Item #1: Regulating Plan

Purpose: To identify opportunities for enhancing the public realm through the District's transforming street network

Sec. 3.11.2. District Character, Subsection 3.11.2.2. Regulating Plan and official zoning map are hereby revised to read as follows:

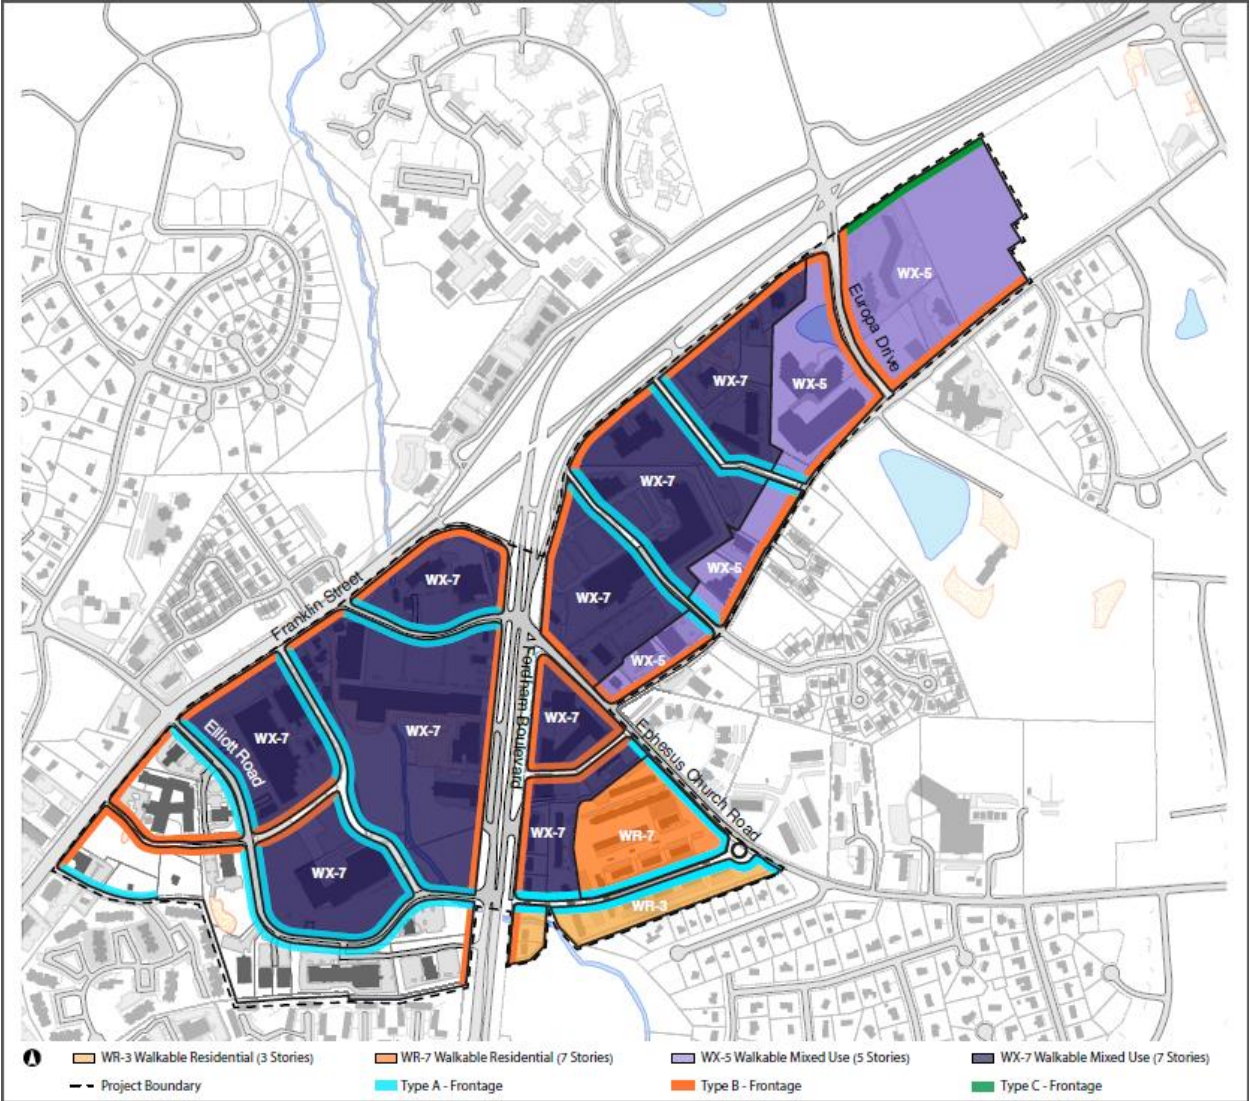
- The Council may consider additional changes to street classifications during the continued public hearing. This would be the opportunity to change the proposed street frontage on the Legion Road extension side of the University Inn property to balance the recommended change on the Fordham Boulevard side of the property.

[The image of the map above is revised to show a Type B frontage in orange along both sides of Fordham Boulevard. The Type C frontage is now shown in green.]

“The Walkable Residential (WR-), Walkable Mixed Use (WX-) subdistricts are identified and located on the Town of Chapel Hill Official Zoning Map. The Regulating Plan is for illustrative purposes and is intended to show the general areas of each subdistrict and associated road frontage(s). Additional street right-of-way or public easement may be required at the time of development, in accordance with the Ephesus Church/Fordham Boulevard Small Area Plan, ~~and~~ this regulating plan or this Section 3.11.”

Q. Building Perimeter

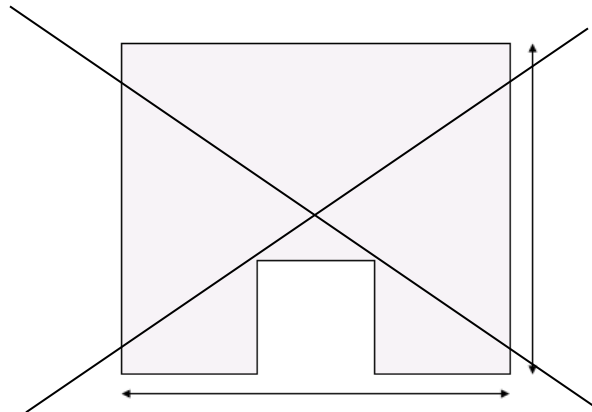
Sec. 3.11.2. District Character, Subsection 3.11.2.7. Measurements and Exceptions is hereby revised to add a new subsection Q. Building Perimeter to read as follows:

1. The building perimeter is measured by summing the lengths of all outer walls of a building at the street level.
2. Where the outer wall of a building is not uniform, the length is measured at street level using a line drawn parallel to the exterior wall the building that is closest to the front setback. The length of this line begins and ends when it crosses the same setback line on the other two adjoining sides of the building as shown in image.

3. Building elements as described in Section 3.11.2.6. and the portions of outer walls used to wrap structured parking do not apply to the maximum building perimeter.”
